S4.55 AMENDMENTS:

TWO SHARED INCH DWELLINGS  
WITH RESIDENTIAL COMMUNITAS  
52 LAUDERDALE AVENUE,  
FAIRLIGHT, NSW  
CLIENT  
DAVID ALBERTA THE CAREY FAMILY TRUST

DRAWING TITLE  
NOTIFICATION PLANS  
SCALE  
1:300  
STATUS  
S4.55  
NUMBER  
A0.01  
REVISION  
S4.55

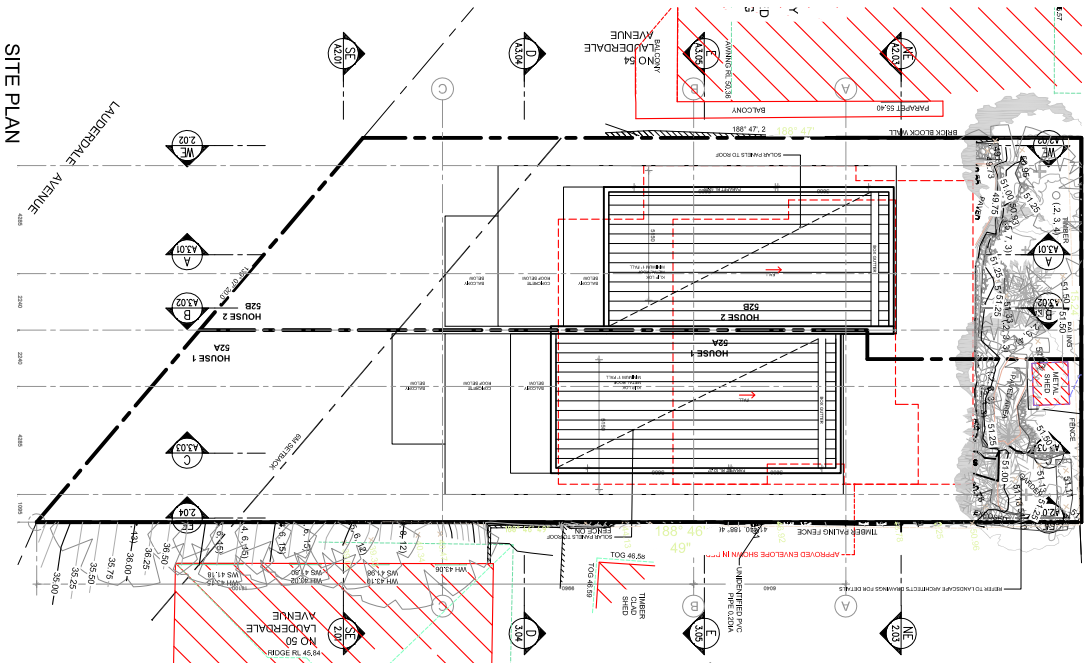
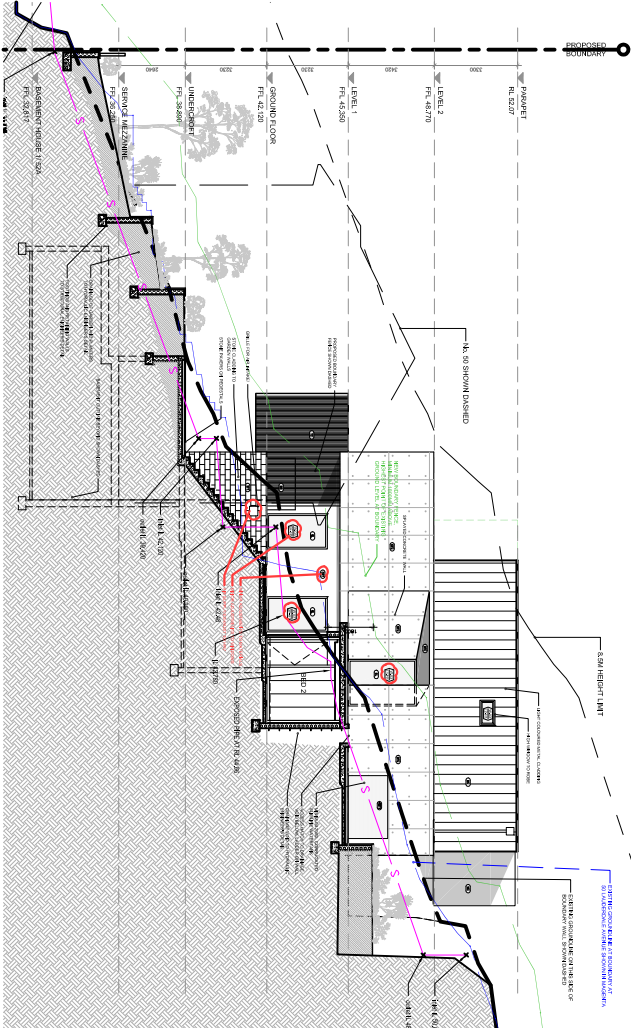
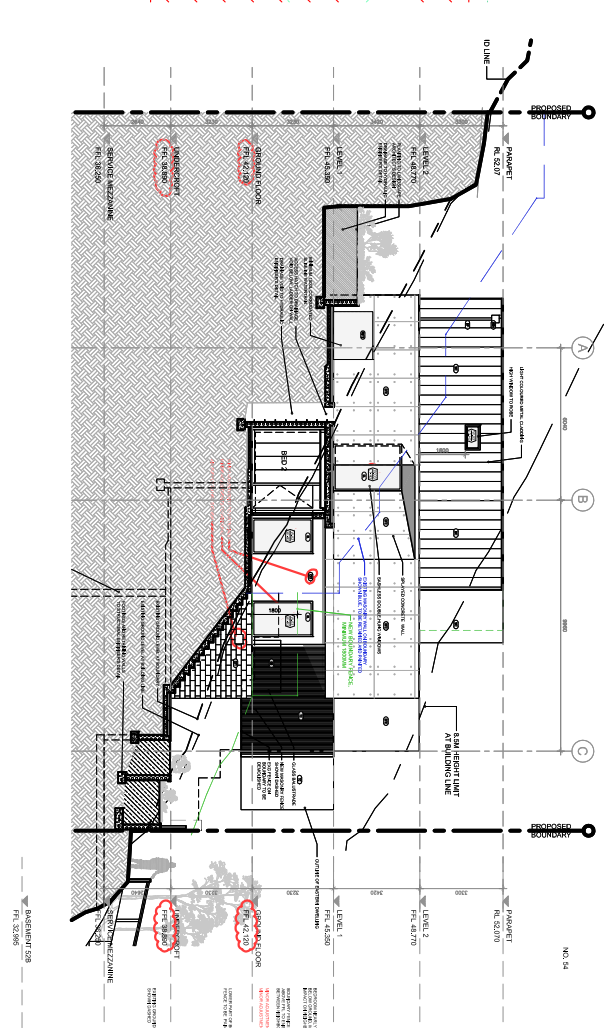
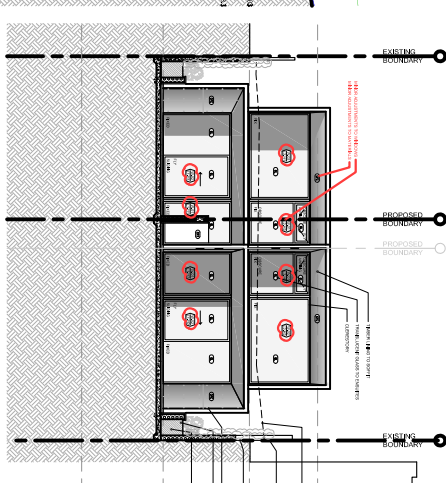
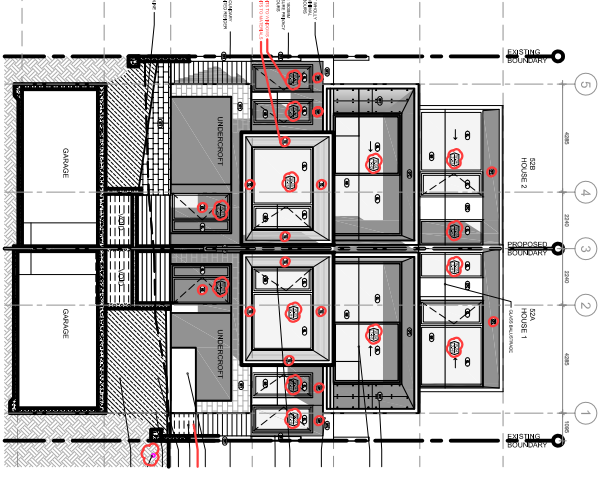
- ADJUSTMENTS OF UNDERCROFT AND GROUND FLOOR LEVELS TO INCREASE CEILING ZONE TO 2.4M TO MEET MINIMUM OVERALL BUILDING HEIGHT STAYS THE SAME
- MINOR ADJUSTMENTS TO THE FENCE AND GARDEN AS A RESULT OF ABOVE
- MINOR EXTERNAL ADJUSTMENTS DUE TO ABOVE POINTS AND DECREASED WINDOW SIZES FOR IMPROVED THERMAL PERFORMANCE
- INTERNAL STAIRS ADDED TO CONNECT THE BASEMENT WITH THE DWELLING ABOVE
